APPLICATION NO.	FILING DATE	FIRST NAMED INVENTOR	ATTORNEY DOCKET NO.	CONFIRMATION NO.
10/653,823	09/03/2003	Toshihiro Takeuchi	SHM-14986	4117
40854 75	2590 11/20/2006		· EXAMINER	
RANKIN, HILL, PORTER & CLARK LLP 4080 ERIE STREET			AMIRI, NAHID	
WILLOUGHBY, OH 44094-7836		ART UNIT	PAPER NUMBER	
			3679	
			DATE MAILED: 11/20/2000	5

Application No.	Applicant(s)				
	10/653,823	TAKEUCHI, TOSHIHIRO				
Office Action Summary	Examiner	Art Unit				
· .	Nahid Amiri	3679				
The MAILING DATE of this communication app Period for Reply	pears on the cover sheet with the c	orrespondence address				
A SHORTENED STATUTORY PERIOD FOR REPL' WHICHEVER IS LONGER, FROM THE MAILING D. Extensions of time may be available under the provisions of 37 CFR 1.1 after SIX (6) MONTHS from the mailing date of this communication. If NO period for reply is specified above, the maximum statutory period of Failure to reply within the set or extended period for reply will, by statute Any reply received by the Office later than three months after the mailing earned patent term adjustment. See 37 CFR 1.704(b).	ATE OF THIS COMMUNICATION 36(a). In no event, however, may a reply be timwill apply and will expire SIX (6)

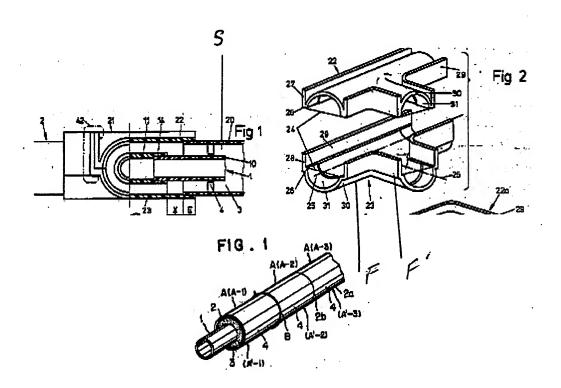
With respect to claim 1, At the outset, it should be noted that patentability in a product-by process claim is based on the resultant structure of the product and not the recited process steps. Kunz et al. disclose a joint frame joint structure (23, Figs. 1-2) comprising a first frame member (F) of U-shaped cross section having a first sidewall, a second sidewall, a bottom wall and an opening (29); a second frame member (F', see attachment), similar to the first frame member, of

U-shaped cross section having an opening (29), said second frame member (F') having an end portion connected to at least one of the first sidewall and the second sidewall of the first frame member (F); a reinforcing member (constituted by the pipe 10) extending into the first frame member (F) and the second frame member (F') by predetermined lengths at a joint of the first frame member (F) and the second frame member (F'); a plate member (22) closing the openings (29) of the first and second frame members (F, F') to form closed cross sections. Kunz et al. does not disclose a foamed resin filling spaces defined by the plate member, the first and second frame member and the reinforcing member. Kikuchi teaches (Fig. 1) a foamed resin (2) placed in a space between the pipe (1) and metal plate (4). It would have been obvious to one of ordinary skill in the art at the time of invention was made to provide a foamed resin as taught by Kikuchi in spaces (S) defined by the plate member (22) the first and second frame members (F, F') and the reinforcing member (10) of Kunz et al.'s invention in order to insulate the pipe against the heat. With respect to the added process recitation pertaining to how the foamed resin is formed, the resultant combination possesses a "foamed resin" and that is all that is necessary to meet the claim.
